FILE NAME = #FILE#	USER NAME = #USER# PLOT SCALE = #SCALE# PLOT DATE = #DATE#	DESIGNED - FSM DRAWN - MNR CHECKED - AAB DATE - 3/18/11	REVISED - REVISED - REVISED - 6/7/11 ADDENDUM ▲ REVISED -	STATE OF ILLINOIS DEPARTMENT OF TRANSPORTATION	HIGHWAY LIGHTING PLANS INTERSTATE 270	FAI 270	SECTION 60-1B-1	COUNTY MADISON	TOTAL SHEETS 712	SHEET NO. 333
		SCALE: 1" = 50' SHEET NO. 5 OF 10 SHEETS STA. 1190+00 TO STA. 1205+00				CONTRACT NO. 76A91 <small>ILLINOIS FED. AID PROJECT</small>

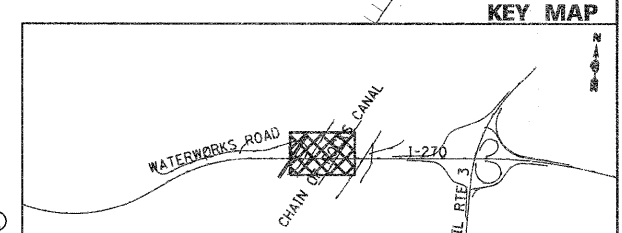
▲ PROPOSED LIGHTING LINE STYLE CHANGE
